THIS SHEET SERVES AS AN ADDENDUM TO SHEET E1.2 BY ADDING LIGHTING SENSORS AND THEIR ASSOCIATED NOTES & WIRING.

CITY OF LAS VEGAS, NEVADA
FIRE STATION #44
ELECTRICAL CAD LIGHTING SENSOR PLAN

ES1.2

ELECTRICAL CAD LIGHTING PLAN

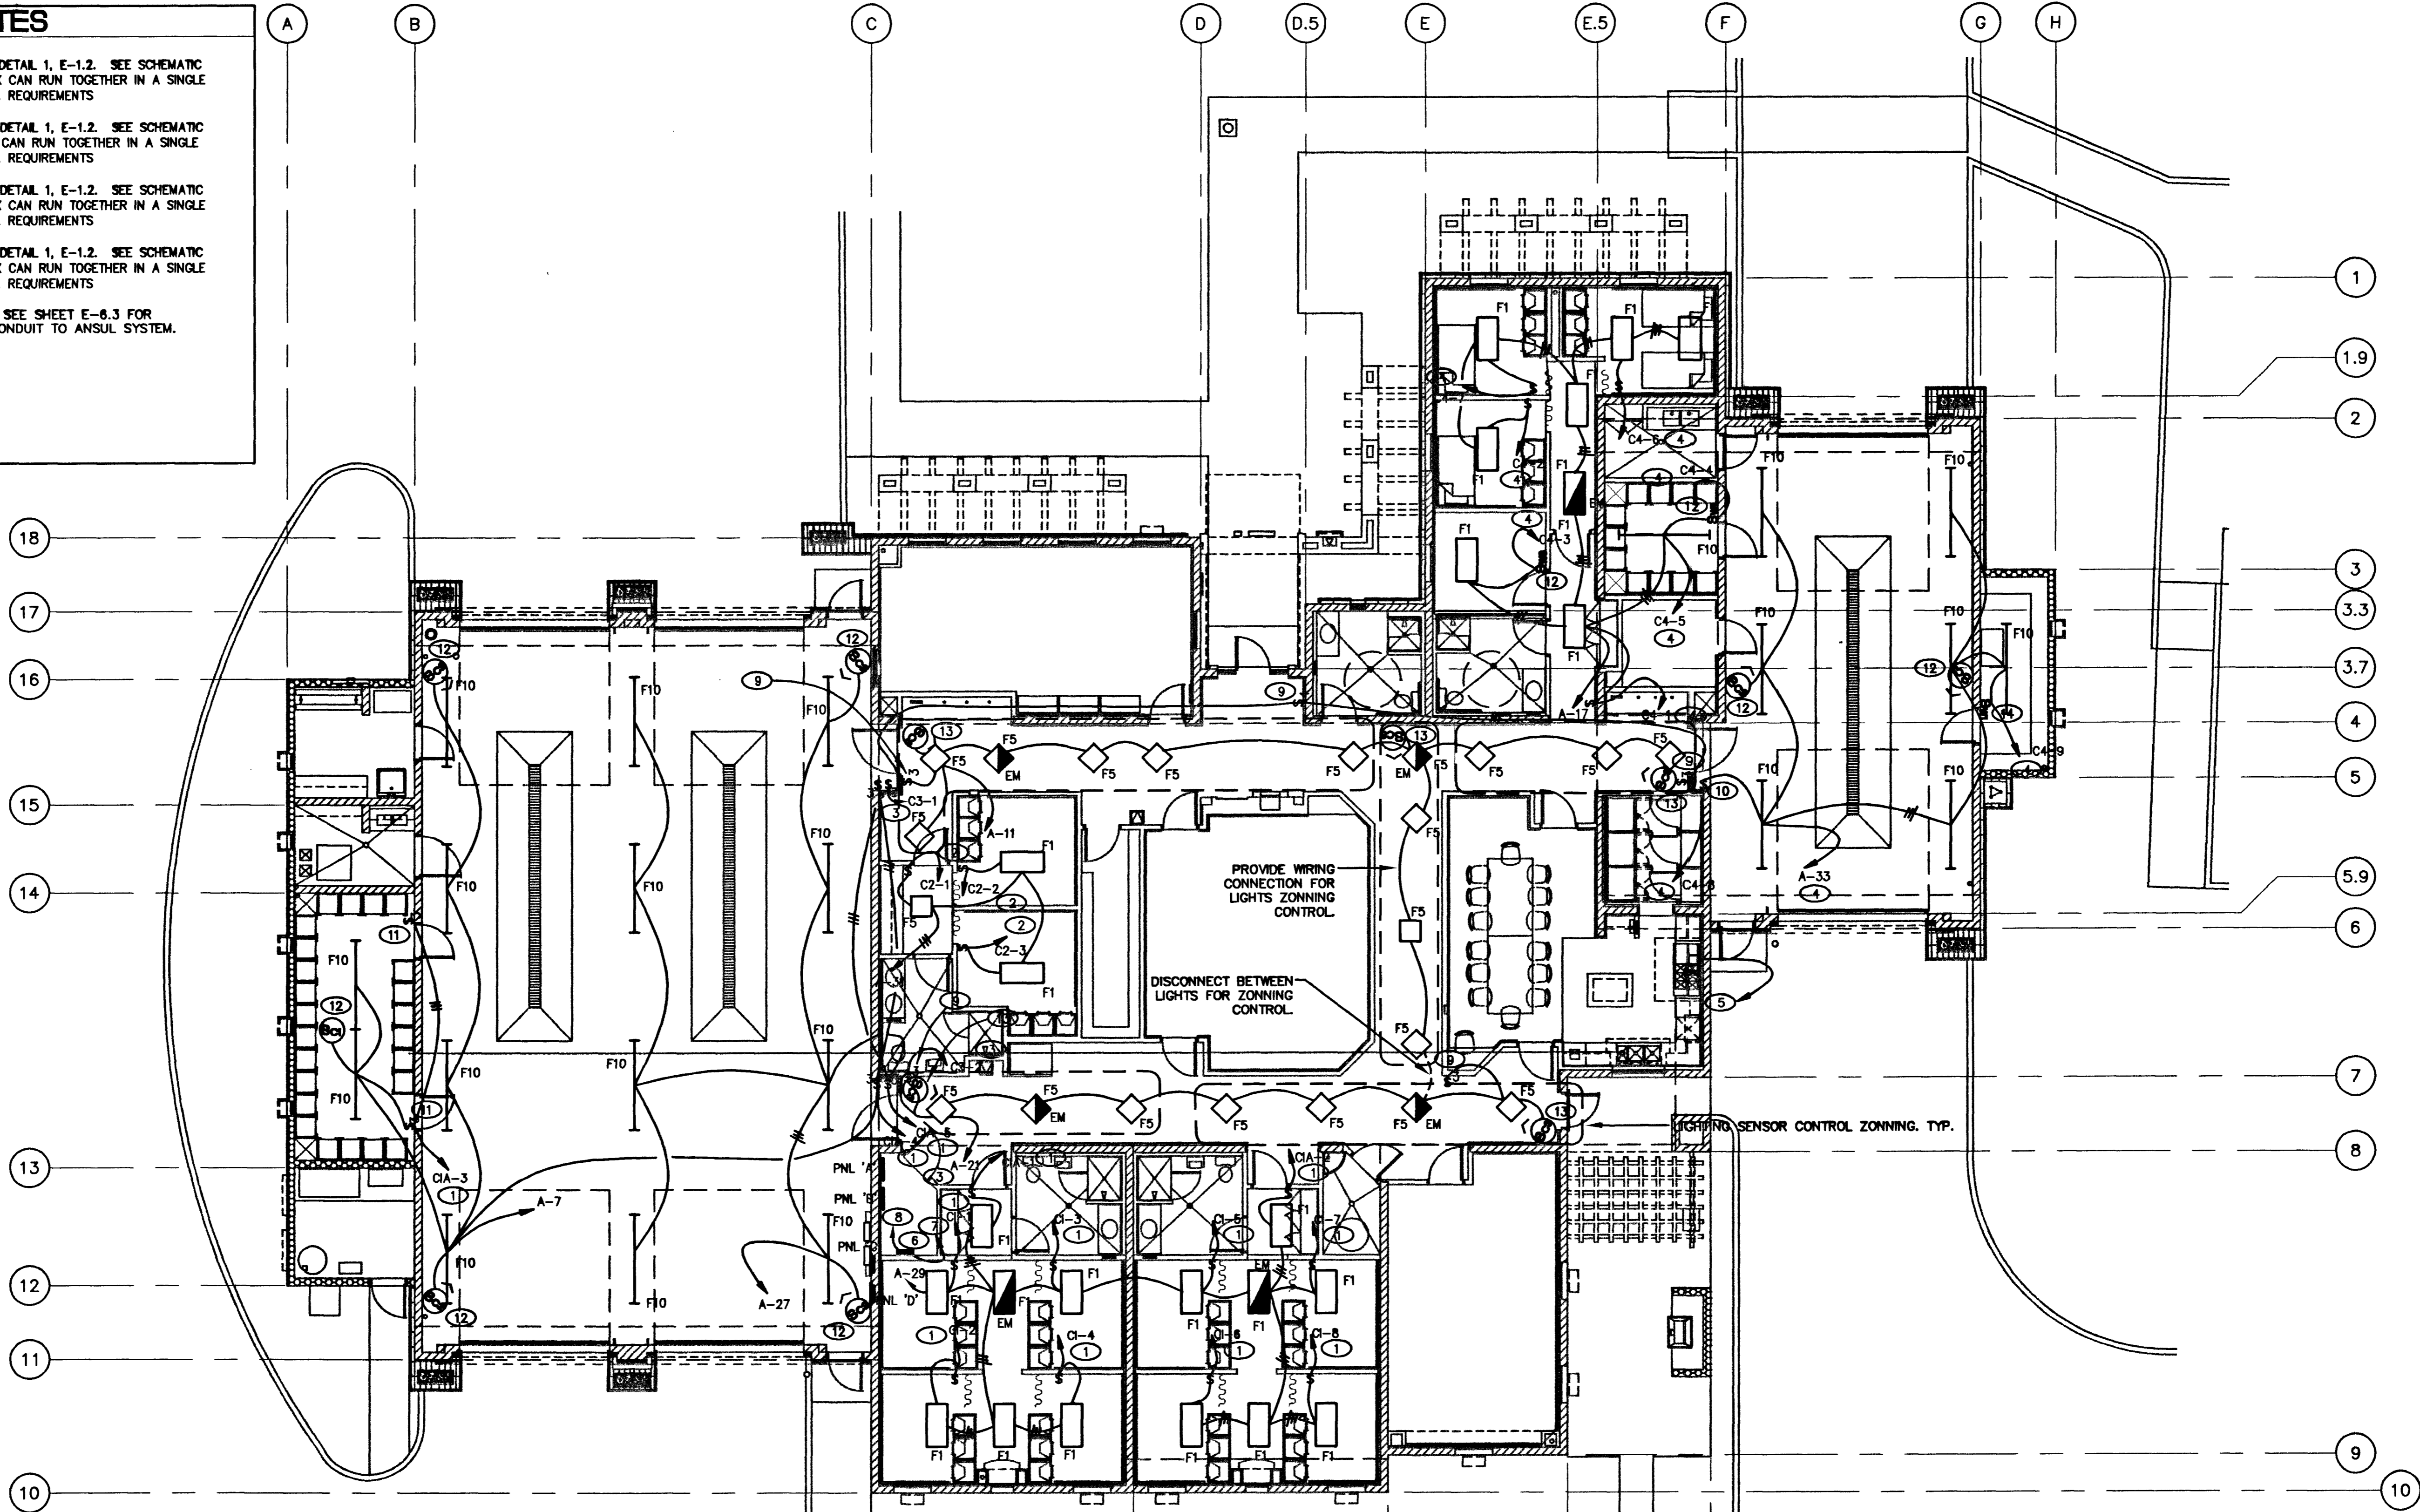
- ⑨ HALLWAY 3-WAY/4-WAY LIGHTING SWITCH TO BE REMOVED. COORDINATE WIRING FOR LIGHTING SENSOR FOR LIGHTING CONTROL IN THE ZONNING AREA.
- ⑩ NOT USED.
- ⑪ 3-WAY SWITCH TO BE REMOVED. COORDINATE WIRING WITH CEILING SENSOR THIS ROOM FOR LIGHTING CONTROL.
- ⑫ BAY AREA LIGHTING SENSOR. MOUNT SENSOR ON WALL 14' AFF. AIMING SENSOR AS INDICATED BY AN ARROW.
- ⑬ HALLWAY LIGHTING SENSOR. MOUNTED ON CEILING. AIMING SENSOR AS INDICATED BY AN ARROW.
- ⑭ PROVIDE NEW WALL SENSOR TO REPLACE WALL SWITCH.
- ⑮ NOT USED.
